LAND USE
DESIGN REVIEW
APPLICATION

ILE NO. LU 13-233011 DZM

OVERTON APARTMENTS

DESIGN RESPONSES TO DAR SUBMITTAL

LEVEL 1 PLAN

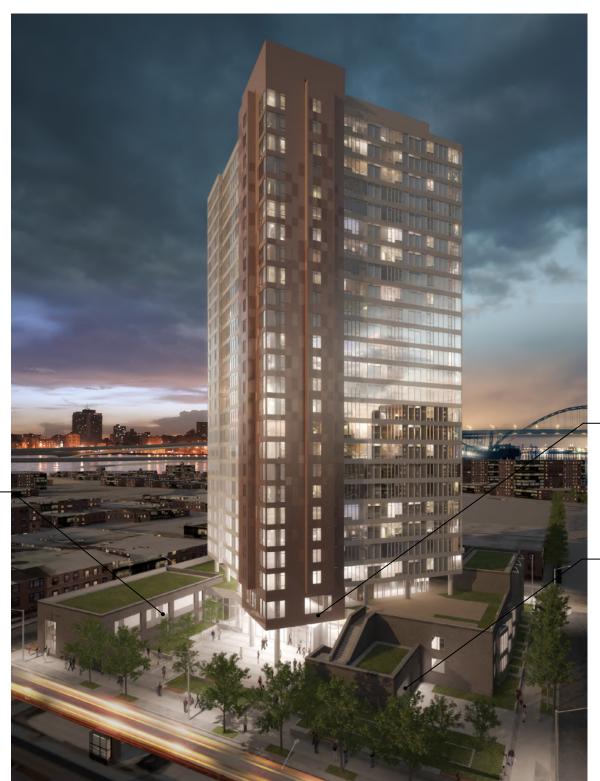
- The on-site vehicle courtyard is wedging a suburban model into an urban space, and should be reconsidered. A porte-cochere and a generous people space at the main/Overton entry courtyard are incompatible uses: pick one or the other. On-site vehicle courtyard will be difficult or impossible to approve.

- The vehicle area/entry court plan is an undefined area with no edges, leading to use of the site for taxi waiting, parking, and stacking of vehicles in a queue.
- The on-site courtyard should be designed for people, not cars. People would be 'in the way' of the cars functionally and visually in the space as designed.
- The courtyard idea has potential as an attractive people space. It has a leftover, inbetween feeling today, and should be reconsidered in light of making it a people space.

The concept of the onsite vehicle courtyard has been eliminated in favor of a smaller scale pedestrian plaza. This plaza has been further condensed to support a friendlier pedestrian environment and experience. Scaling down was accomplished through a few different means. The enclosure of the garage entry removes the visual connection to vehicles entering and exiting the garage. Planter areas surrounding the plaza have been increased in size to soften the building edges and offer interest for the pedestrian, and the south glazed wall of the entry lobby has been moved south, closer to the street, to give the building more presence and connection to the streetscape.

Visible tower corner engages with entrance at plaza

Addition of enclosed parking entry
